# TOWN OF PLYMOUTH

ADDENDUM 2

TO: Potential Bidders  
FROM: Ashley Leaman, Procurement Assistant  
DATE: July 22, 2016  
RE: 21611, Joseph Simes House Renovations Phase 2

Asbestos Removal  
 Work Area Sketch

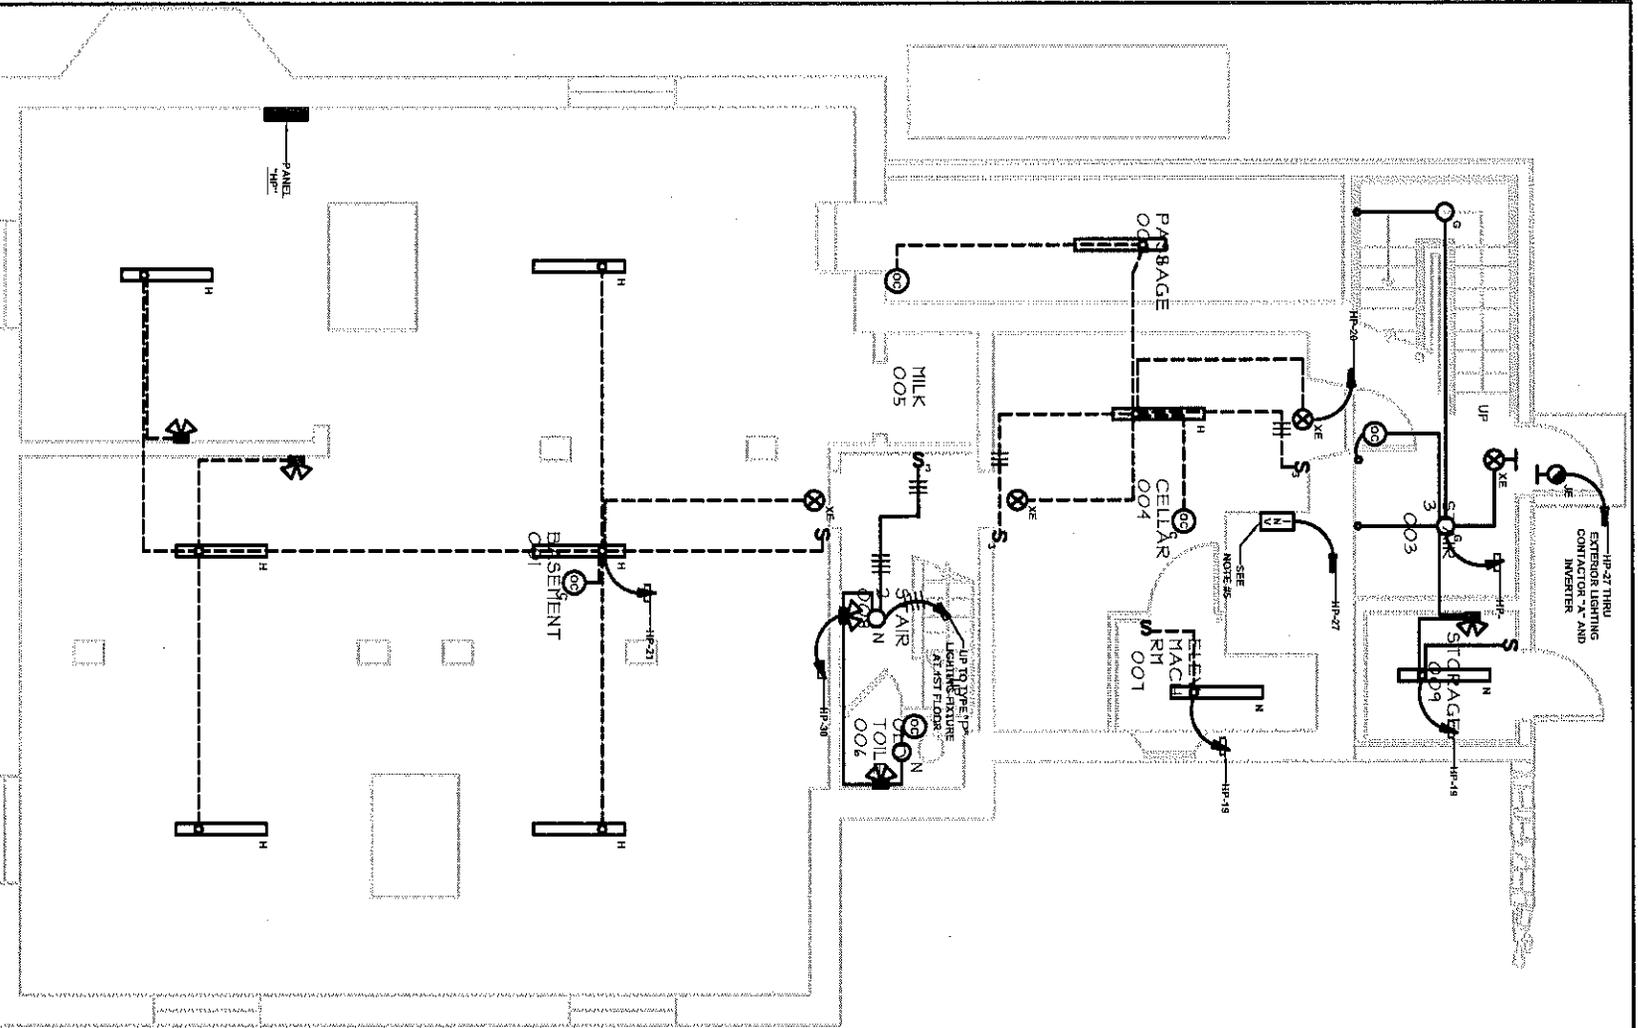
ADD attached Asbestos Removal Work Area Sketch dated June 15, 2016

**SKE-1**

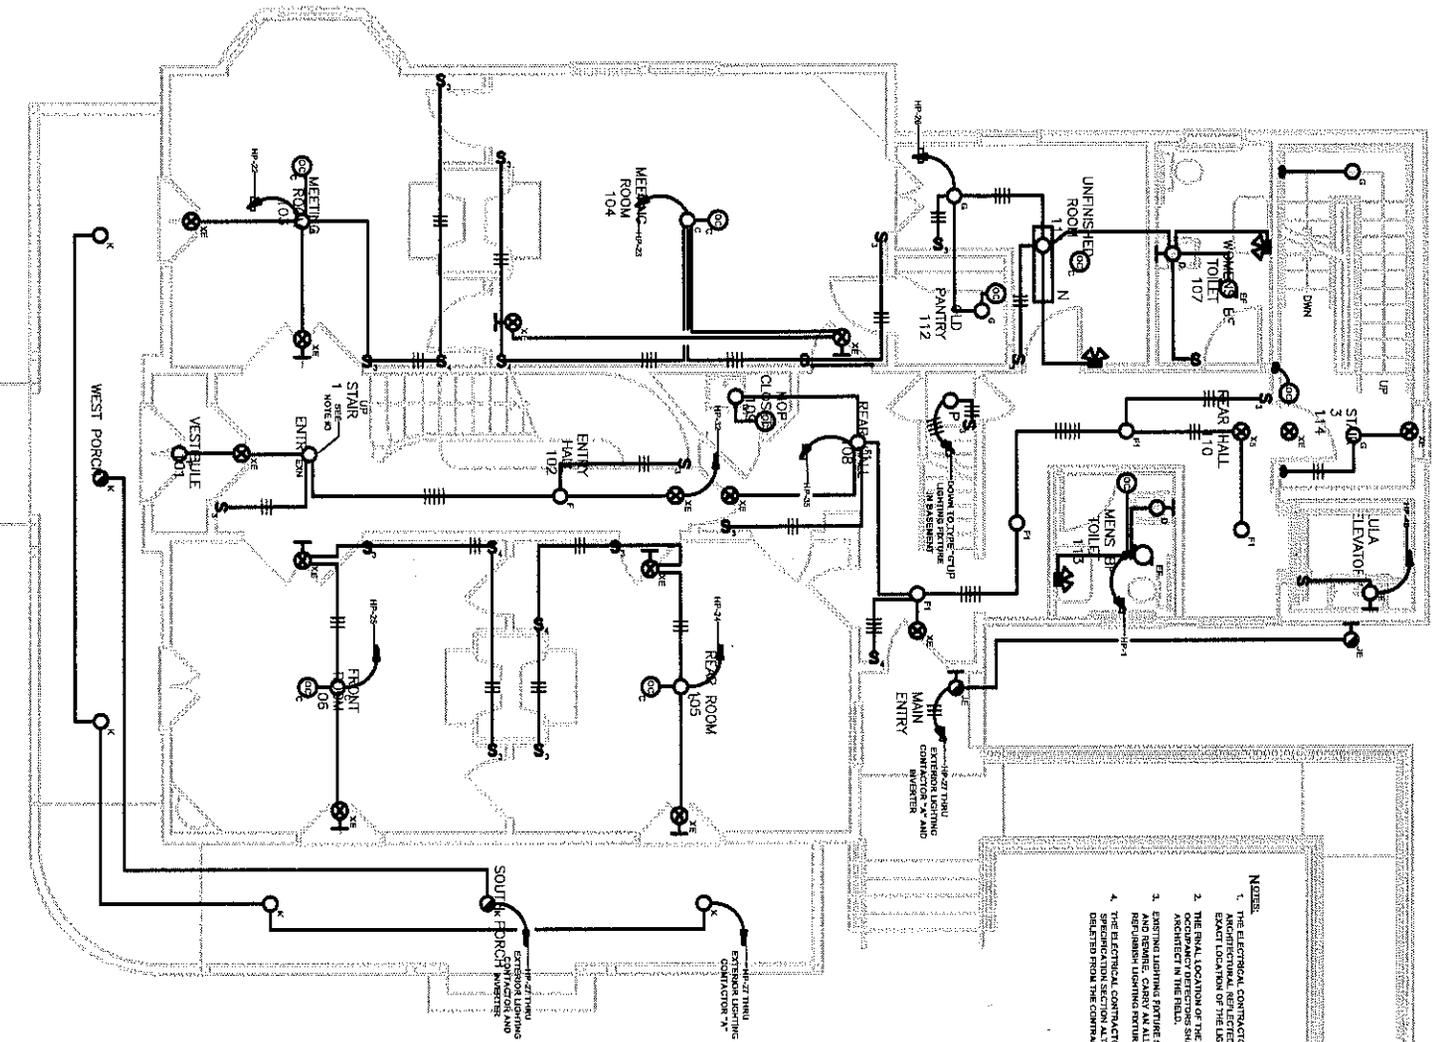
CHANGE: 3 G type fixtures @ rooms 006 & 008 to 2 N type fixtures  
N type fixture @ outside egress door from Stair 3 (room 003) to J type fixture

**See attached SKE-1 BASEMENT FLOOR LIGHTING PLAN dated 07-21-16**
